FEDERAL PROJECT NO. STP-9901 (673)

ADDENDUM NO. 2

UNION/LINDELL BRIDGE REPLACEMENT

DATE: **10/15/26**

PLAN 9 FOREST PARK PKWY

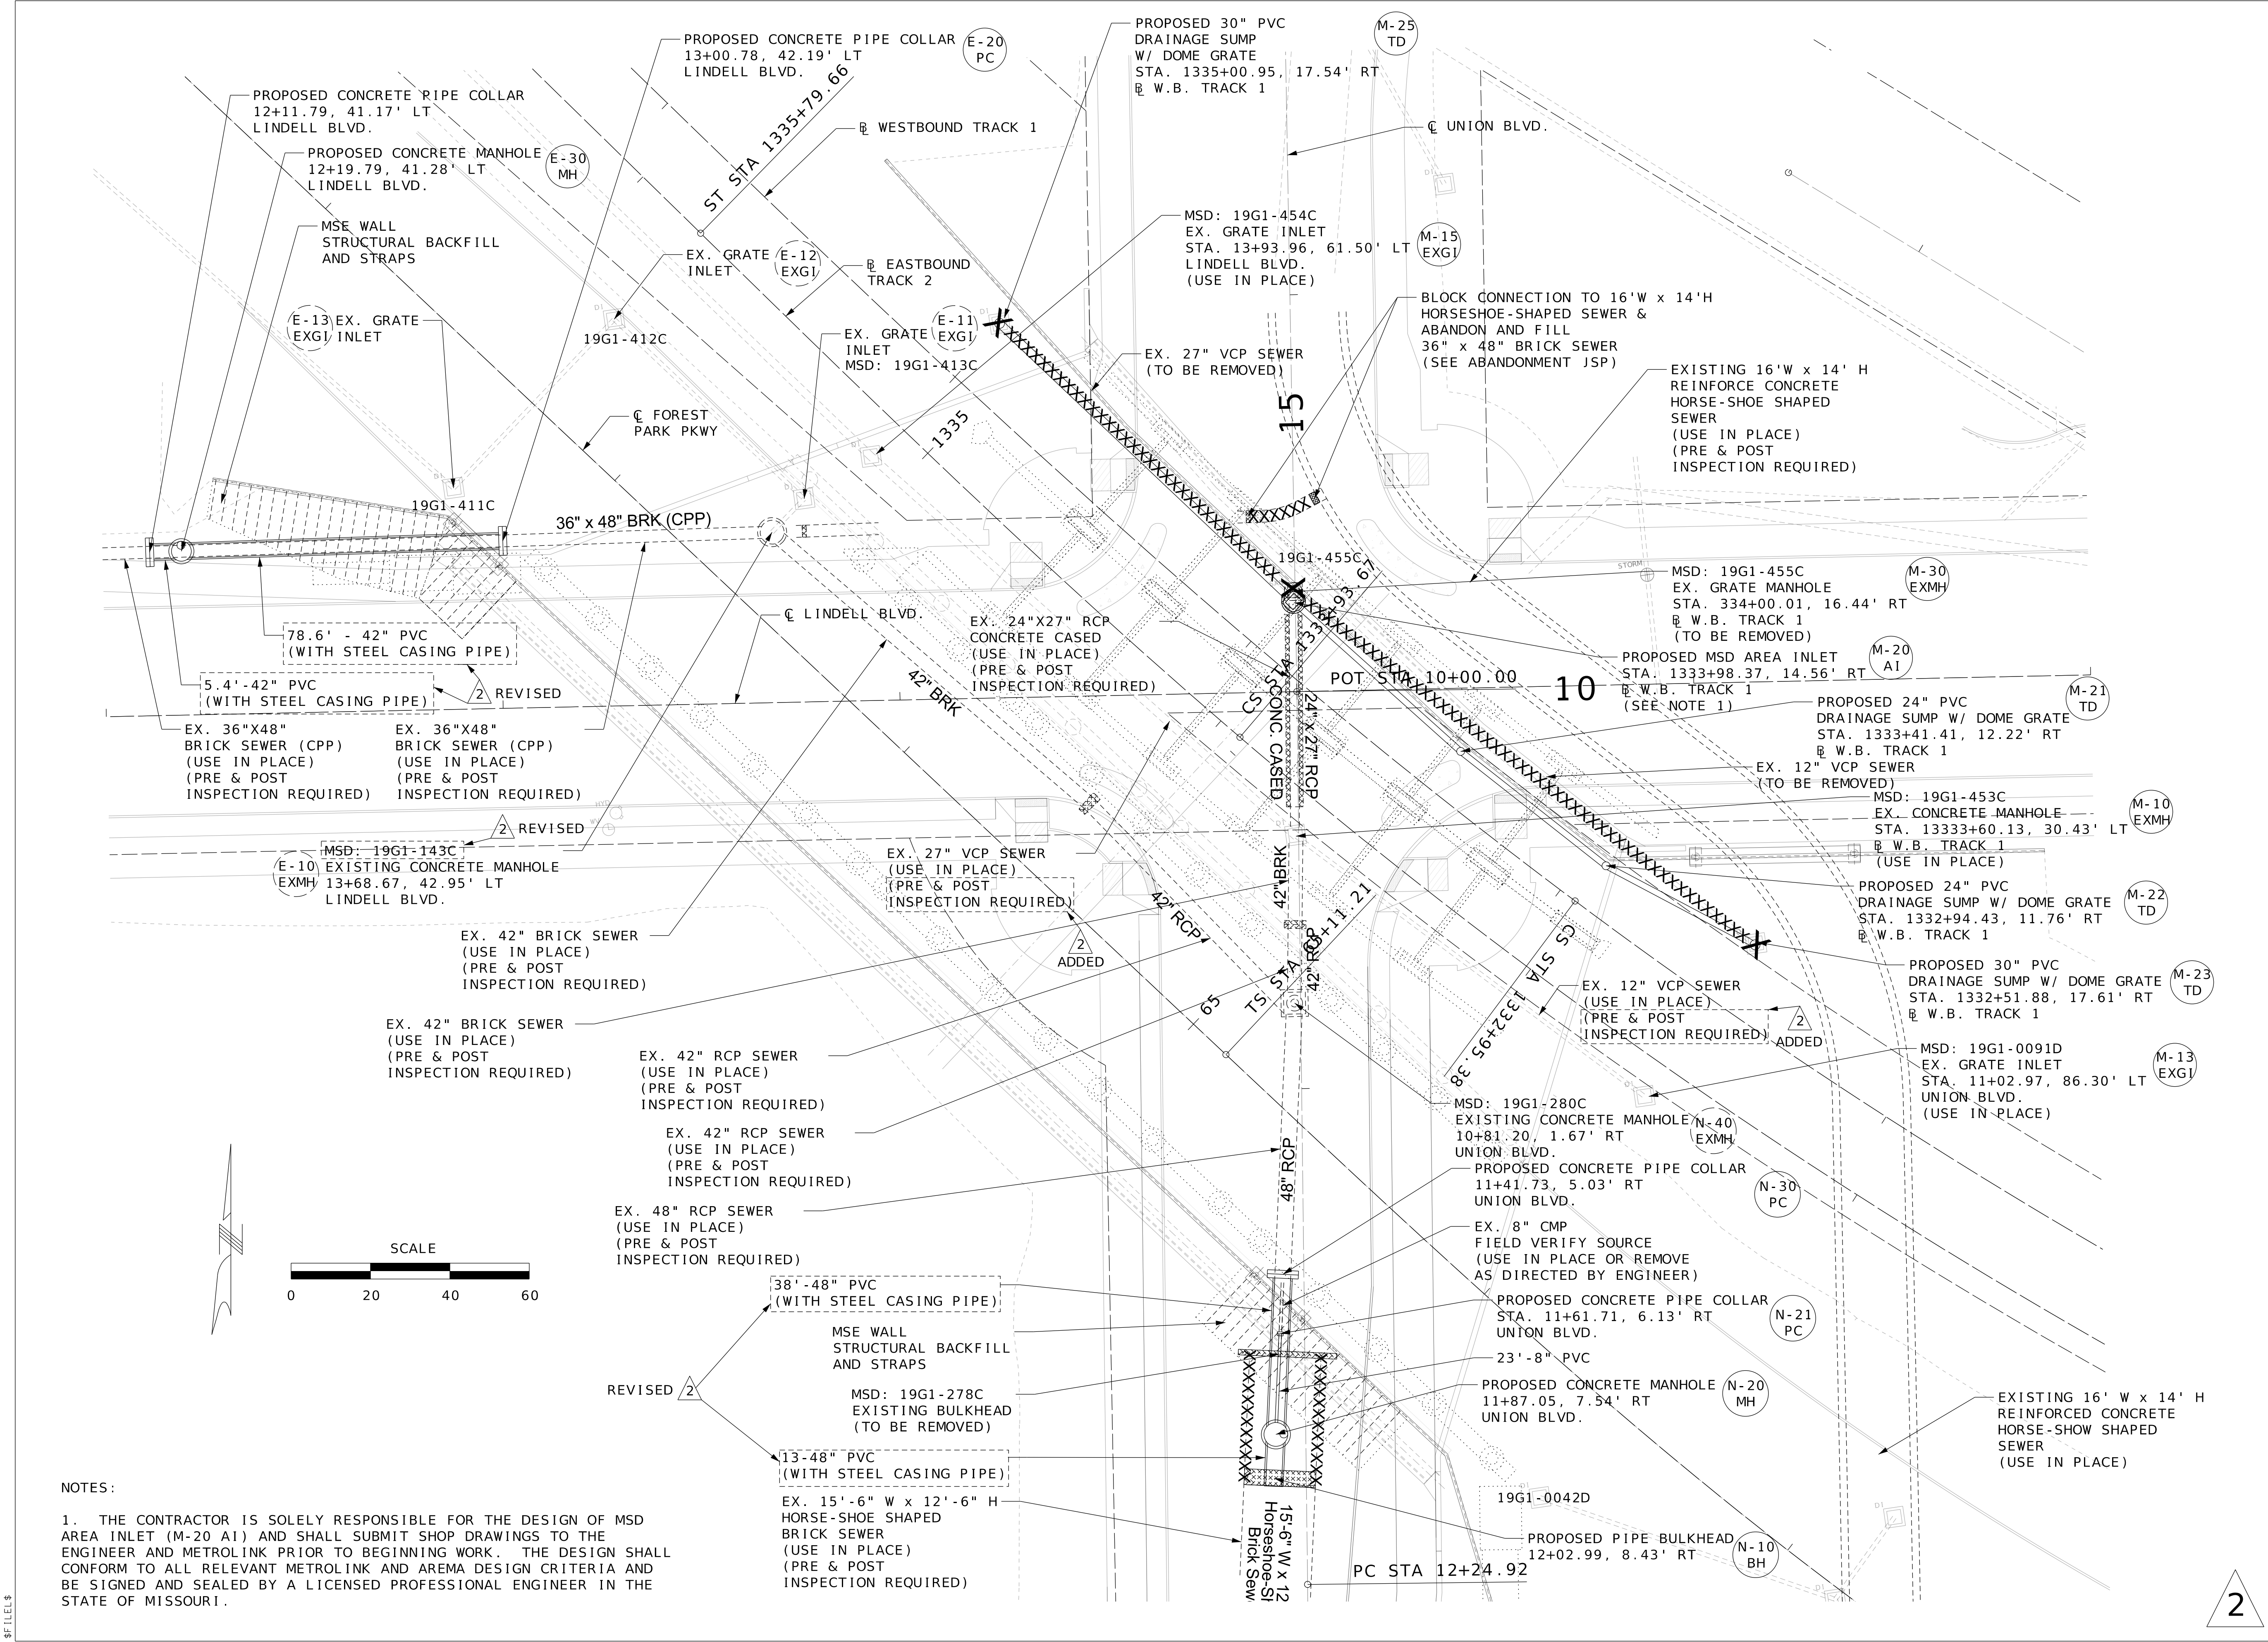
- The following plan sheets have been revised to reflect updated design calculations for storm runoff into the MSD system.
 - Cover Sheet, 2B.2, 2B.3, C4.6, C4.9, C7.2, C7.3, C7.4, C7.5, C7.6, C7.7, C7.8, C7.9, C7.11, CV7.12, C7.13, and C7.14
- The following plan sheets have been revised to clarify the MSE wall standpipe. All work related to the standpipe is considered incidental to the MSE wall.
 - SW-01, SW-04
